Project Name: Buddha Skybar

Project Location: 217 E. Atlantic Avenue

Request: Class IV Site Plan Modification

SITE PLAN REVIEW AND APPEARANCE BOARD

SP.1
SHEET NO.

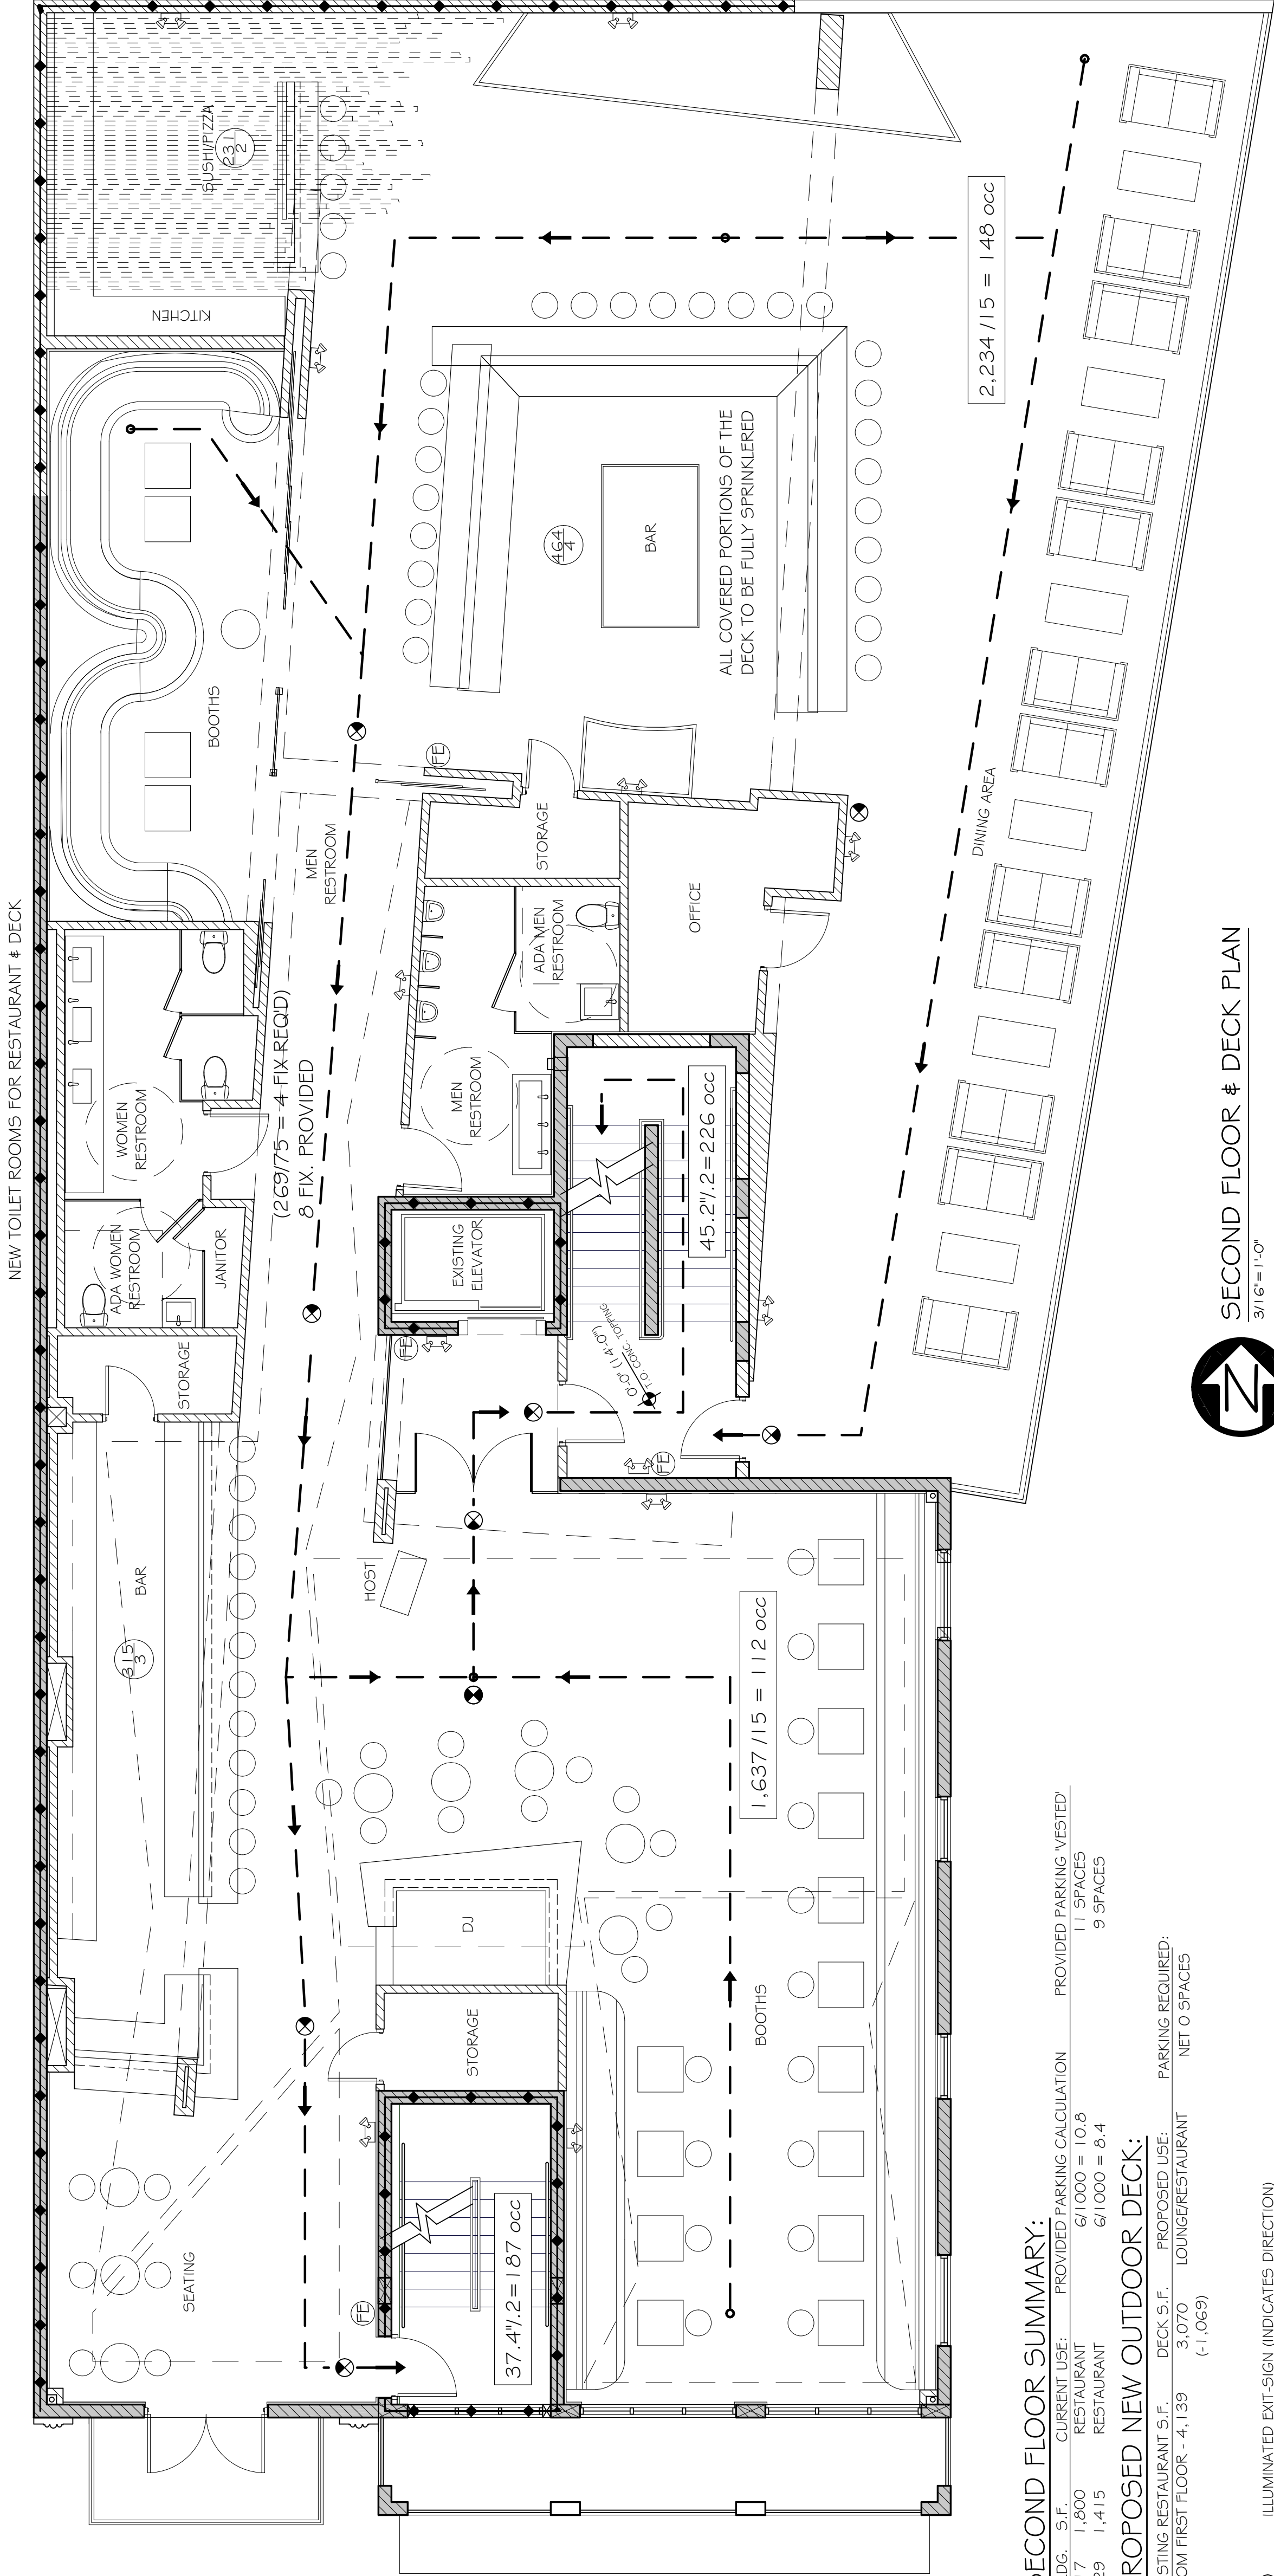
- Site Plan SP.1 shows a proposed lateral connection into an existing water main along the rear alley way.
- Site Plan SP.1 shows a proposed lateral connection into an existing sanitary sewer main along rear alley way.
- Pursuant to the City’s Comprehensive Plan, treatment capacity is available at the City’s Water Treatment Plant and the South-Central County Wastewater Treatment Plant for the City at build-out. Based upon the above, positive findings can be made with respect to this level of service standard.
